**Development Permit Panel**

**1. DEVELOPMENT PERMIT 20-899883**  
(REDMS No. 6662572)

**Re:** Application by Orion Construction for a Development Permit at 3640 No. 4 Road

**1. DP 20-899883 – TWO TWO-STOREY INDUSTRIAL BUILDINGS**

NORTH ELEVATION  
1:300

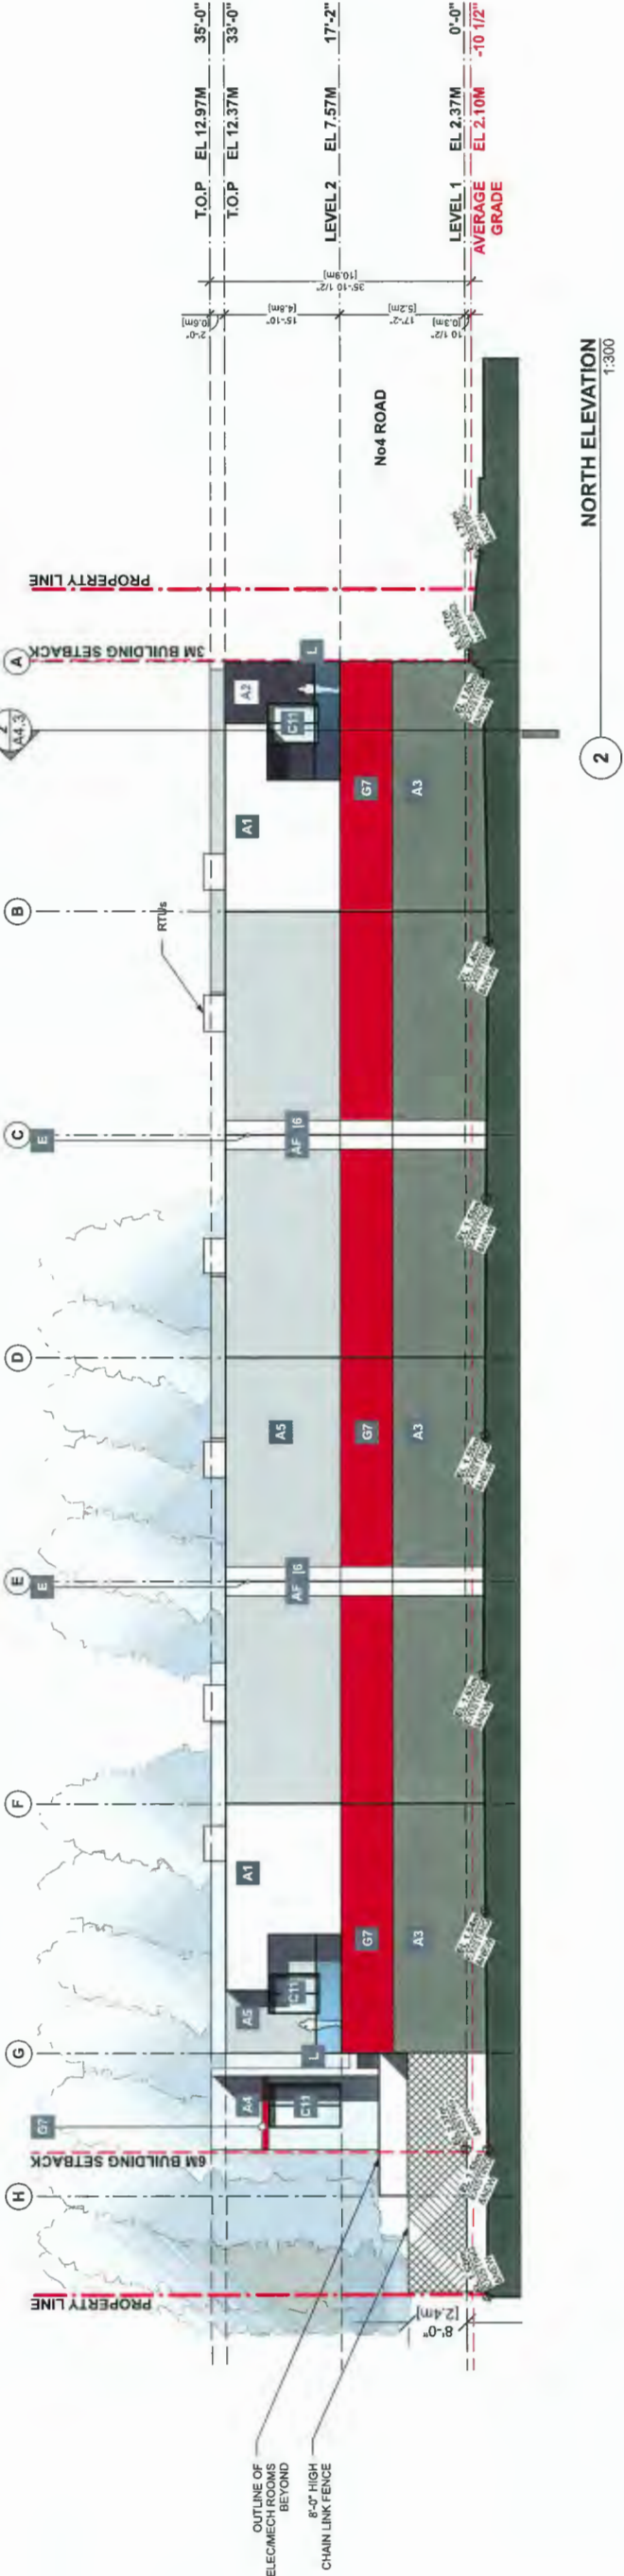
- concerned about the design of the north building's (Building A's) north elevation, i.e., its openings, colour treatment, finishes and balconies should the future development on the neighbouring property to the north include no setback; the applicant needs to review the design of the north façade to provide an appropriate interface with the future development to the north;

- appreciate the applicant's approach to the interim condition of the north façade as a future development on neighbouring property could have no setback; like proposal to paint the middle portion of the north façade of the north building (i.e., gridlines B to F) to provide visual interest to the exposed concrete wall; also appreciate the balconies at the east and west ends of the north elevation;

- appreciate the applicant's response to the concern with regard to the proposed treatment of the north façade; expect to see some colour changes to the north facade;
